# Access Compliance Report

## Public Rights-of-Way

Intersection ID: 28390	Main Street: ARDREY_KELL_RD	Cross Street: BRIDGEHAMPTON_CLUB_DR	Location: NE
ADA ID: E8D49434FB5F	Ramp Type: Perp	Initial Pass/Fail: Fail	Overall Compliance: No
Severity Score: 1.25			
Codes/Mitigation Info/Possible Solution		Field Measurements/Component Compliance

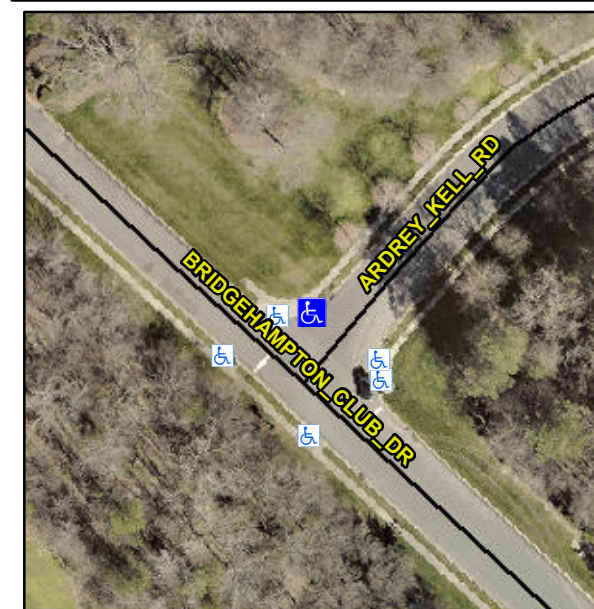
**Not Found, R304.5.3**

Compliance	Description	Data	Compliance	Description	Data
N/A	Ramp Length (in)	47.0	Yes	Ramp Slope (%)	6.1
Yes	Ramp Width (in)	61.0	No	Ramp XSlope (%)	2.4
N/A	Flare Type LT	N/A	N/A	Flare Type RT	N/A
N/A	Flare Slope LT (%)	N/A	N/A	Flare Slope RT (%)	N/A
N/A	Flare Traversable LT?	N/A	N/A	Flare Traversable RT?	N/A
N/A	Landing Length (in)	N/A	N/A	DWS Provided?	N/A
N/A	Landing Width (in)	N/A	N/A	DWS Contrast?	N/A
N/A	Landing Slope (%)	N/A	N/A	DWS Length (in)	N/A
N/A	Landing X Slope (%)	N/A	N/A	DWS Full Width?	N/A
N/A	Landing Curb? (Y/N)	N/A	N/A	DWS Offset (in)	N/A
N/A	Shared Landing?	N/A			
N/A	Gutter Ponding?	N/A	N/A	Gutter Slope (%)	N/A
N/A	Gutter Lip Ht (in)	N/A	N/A	Gutter X Slope (%)	N/A
N/A	Painted X Walk1?	No	N/A	Painted X Walk2?	N/A
	X Walk 1 Direction	To SE		X Walk 2 Direction	N/A
N/A	X Walk 1 Width (in)	N/A	N/A	X Walk 2 Width (in)	N/A
	X Walk 1 Slope (%)	4.3		X Walk 2 Slope (%)	N/A
	X Walk 1 X Slope (%)	0.5		X Walk 2 X Slope (%)	N/A

**Remove & Replace Entire Ramp.**
